**ZONING AMENDMENT,
PLANNED UNIT DEVELOPMENT &
SUBDIVISION STAFF REPORT****Date: November 15, 2018**

<u>NAME</u>	Abhishek Banerjee
<u>SUBDIVISION NAME</u>	Villas at Spring Hill Subdivision
<u>LOCATION</u>	162 and 186 East Drive (West side of East Drive, 130'± North of Sussex Drive, extending to the East side of Center Street).
<u>CITY COUNCIL DISTRICT</u>	District 6
<u>PRESENT ZONING</u>	R-1, Single-Family Residential District
<u>PROPOSED ZONING</u>	R-2, Two-Family Residential District
<u>REASON FOR REZONING</u>	An increased need for multi-family housing.
<u>AREA OF PROPERTY</u>	24 Lots / 4.0± Acres
<u>CONTEMPLATED USE</u>	<p>Subdivision approval to create 24 legal lots of record from two legal lots of record, Planned Unit Development approval to allow reduced front and side yard setbacks for a proposed subdivision, and Rezoning from R-1, Single-Family Residential to R-2, Two-Family Residential.</p> <p>It should be noted, however, that any use permitted in the proposed district would be allowed at this location if the zoning is changed. Furthermore, the Planning Commission may consider zoning classifications other than that sought by the applicant for this property.</p>

APPLICATI

SITE PLAN

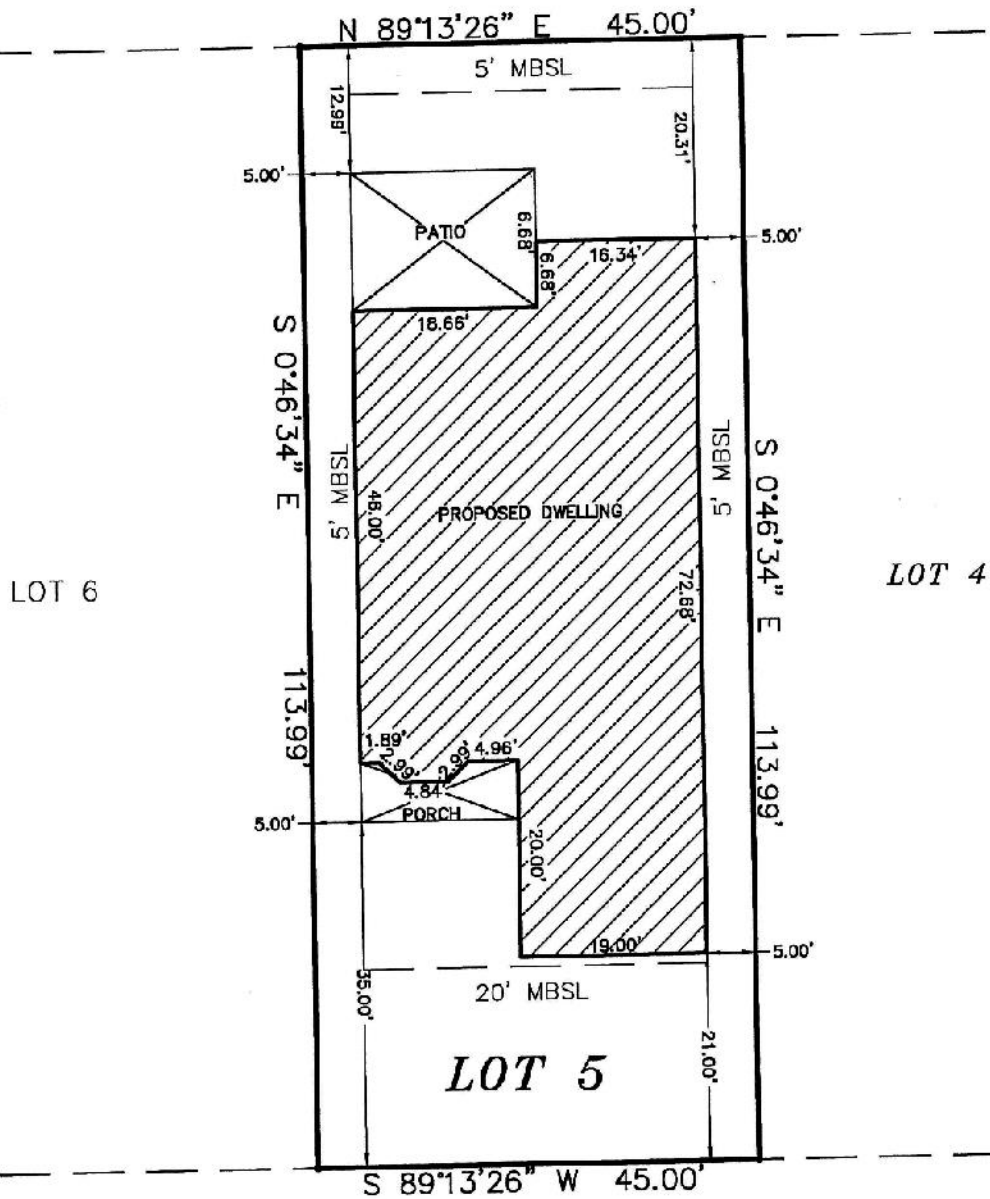
As reduced minimum building setback lines are proposed, a waiver of Section V.D.9. would be required. The preliminary plat indicates the proposed reduced minimum building setback lines along all street frontages. However, the setback line along the front of Lots 10 through 15 is not labeled or dimensioned. Therefore, the plat should be revised to label this line as the minimum building setback line and provide the dimension from the front property line. The minimum building setback line along all other street frontages should be retained on the Final Plat. The plat does not illustrate the proposed side and rear yard setbacks; therefore, the plat should be revised to illustrate any reduced side yard and rear yard setbacks. The rear setback line for Lots 16 through 24 should be adjusted to align with the 10' drainage easement.

The PUD site plan mirrors the subdivision preliminary plat and revisions required of the preliminary plat would also be required of the PUD site plan. The site plan should also be revised to provide a public sidewalk along all street frontages, or a Sidewalk Waiver application should be submitted.

Two typical site plans are provided with the PUD, one for Lot 5, and one for Lot 20. They are identical, except that the Lot 20 plan indicates the 10' drainage easement along the rear (South) of the lot. However, the proposed 5' rear setback line is illustrated within the drainage easement. As no structure is allowed to be placed or constructed within an easement, the site plan for Lot 20 should be revised to remove the 5' minimum building setback line from within the easement and relocate it to coincide with the 10' drainage easement line. This revision should also be done for Lots 16 through 24. All other reduced minimum building setback lines should be illustrated on all lots on a revised site plan. As a maximum site coverage of 50% is proposed, a note should be required on a revised PUD site plan stating that the maximum allowable site coverage for all lots is 50%.

- 13) revision of the site plan for Lot 20 to remove the 5' minimum building setback line along the rear from within the drainage easement and relocate it to coincide with the 10' easement line;

- 14) revision of the site plan to adjust the rear setback line for Lots 16 through 24 to be out of the 10' drainage easement;
- 15) placement of a note on the site plan stating that no structure may be constructed or placed within any easement;
